## TECHNICAL SERVICE BULLETIN

SUBJECT:  <h3 style="text-align: center;">CHIRPING NOISE FROM DRIVE BELT</h3>		No: <b>TSB-07-11-005</b> <hr/> DATE: <b>August, 2007</b> <hr/> MODEL: <b>2006 - 2007 Raider</b> ◀	
CIRCULATE TO:	<input type="checkbox"/> GENERAL MANAGER	<input checked="" type="checkbox"/> PARTS MANAGER	<input checked="" type="checkbox"/> TECHNICIAN
<input checked="" type="checkbox"/> SERVICE ADVISOR	<input checked="" type="checkbox"/> SERVICE MANAGER	<input checked="" type="checkbox"/> WARRANTY PROCESSOR	<input type="checkbox"/> SALES MANAGER

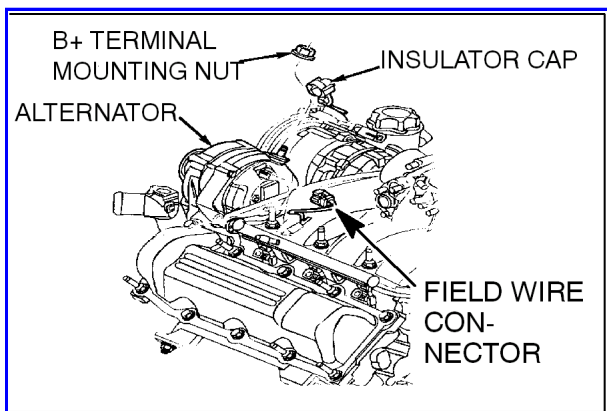
On some affected vehicles, the accessory drive belt may make a chirping sound when the steering wheel is turned to full lock (typically during parking maneuvers). To eliminate this condition, replace the alternator pulley with a new, improved pulley equipped with an overrunning clutch, listed in the PARTS INFORMATION section of this bulletin.

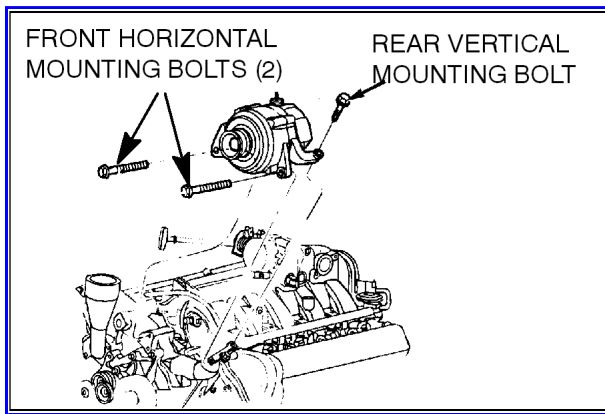
1. Confirm that the chirping noise occurs when the steering wheel is turned to full lock.
2. Record the radio presets and disconnect the negative battery cable at the battery.
3. Loosen the accessory drive belt. Then remove the alternator:

- a. Unsnap the plastic insulator cap from the B+ output terminal.
- b. Remove the B+ terminal mounting nut at the rear of the alternator. Disconnect the terminal from the alternator.
- c. Disconnect the field wire connector by pushing on the connector tab.

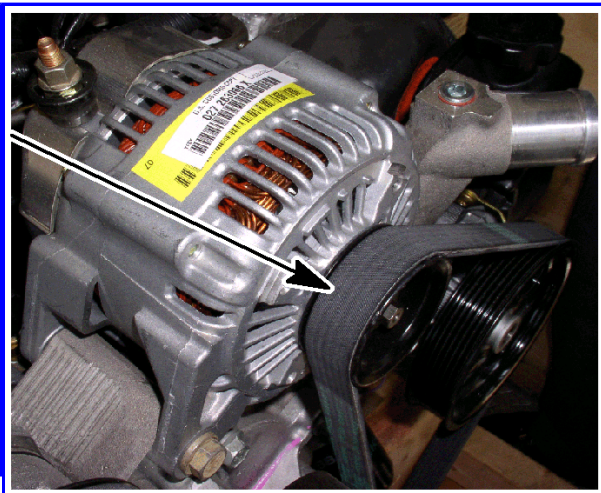
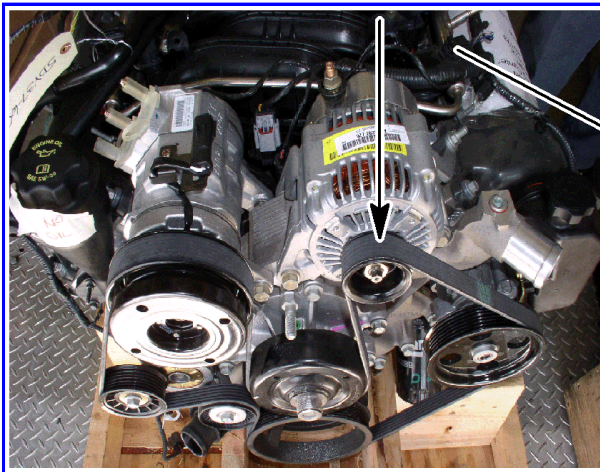
d. Remove one rear vertical mounting bolt and two front horizontal mounting bolts.

4. Remove the alternator pulley.

5. Install the appropriate quantity of spacers to achieve proper alignment of the overrunning pulley and the accessory drive belt, and between the pulley and the alternator housing. Then install the new pulley.
